Mar. 27th, 2023

METB Series Profile Change Notification

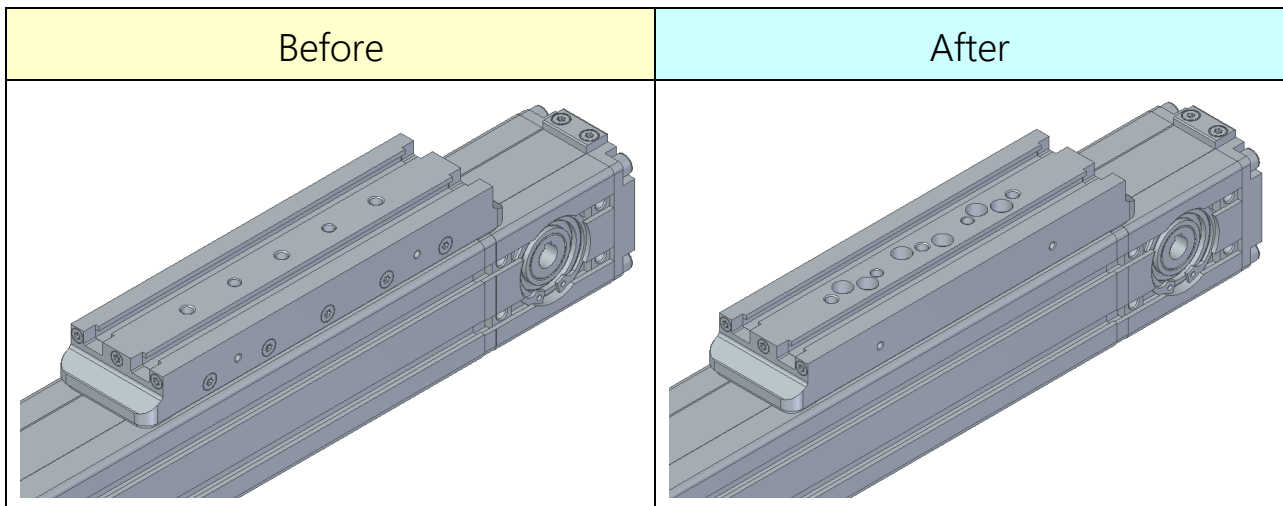
In order to simplify the installation method of the slide table, the appearance is changed. It does not affect the customer's installation hole location and size.
